31 March 2020

Our ref: 12528516-49422-2
Your ref:

Airly Mine SSD 5581 Modification 3 Response to DPIE Water Submission

Figure 2 Predicted mine inflows under approved and proposed conditions

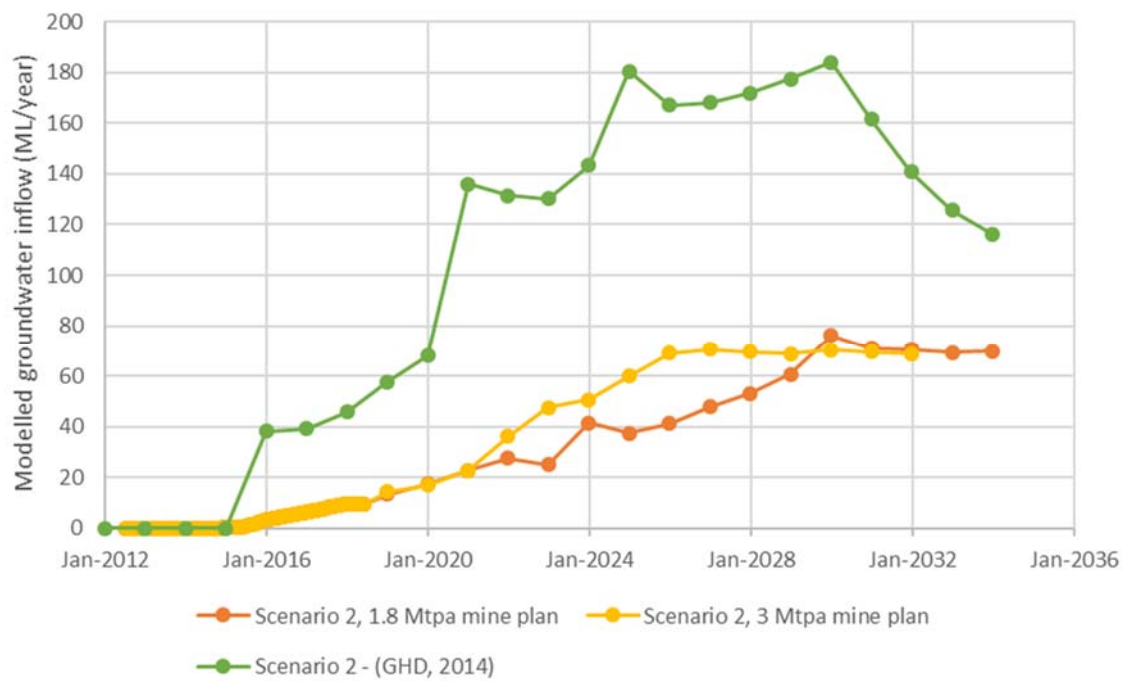
- Revise the Numerical Groundwater Model by incorporating all monitoring data up to the end of 2019 and the altered mining methods for the revised future mining plan and panels (i.e. post 2017) including, as a minimum fracturing patterns consistent with 'Scenario 2'.
- Prepare a comprehensive discussion of any variations noted compared to the outcomes for the 2018 model variant. The report should include a discussion of altered impacts arising from an increased presence of active subsidence fracturing with resulting hydraulic connection to shallow aquifers and surface water systems. A revised assessment of impacts against the criteria of the NSW Aquifer Interference Policy (2012) and an update on licensing requirements if required. Further analysis should be provided of the overlying 3rd order streams and how these are being considered within the groundwater model.

Predicted groundwater inflows into the mine under each of the three conditions are shown in Figure 2. Groundwater inflows predicted using the original model and approved under SSD 5581 peak at 184 ML/day and are labelled in Figure 2 as GHD (2014). These inflows are substantially higher than inflows predicted using the updated model, for both approved and proposed conditions. Observed mine inflows have been low (not measureable) to date and therefore the lower inflows modelled by the updated model are considered to be more realistic (refer Section 3).

Under Scenario 2 and the 3 Mtpa mining rate (proposed conditions) the modelled groundwater inflow rate increases over time to a peak of 71 ML/year in 2027, before gradually decreasing to 69 ML/year in 2031. Under the proposed 3 Mtpa mining rate the peak inflow is predicted to occur earlier than for the approved 1.8 Mtpa mining rate, however the peak inflow is predicted to be slightly higher for the 1.8 Mtpa mining rate (76 ML/year). Mine inflows for both the 1.8 Mtpa mining rate and the 3 Mtpa mining rate are similar at the end of mining as the mine plan has the same footprint for both scenarios.
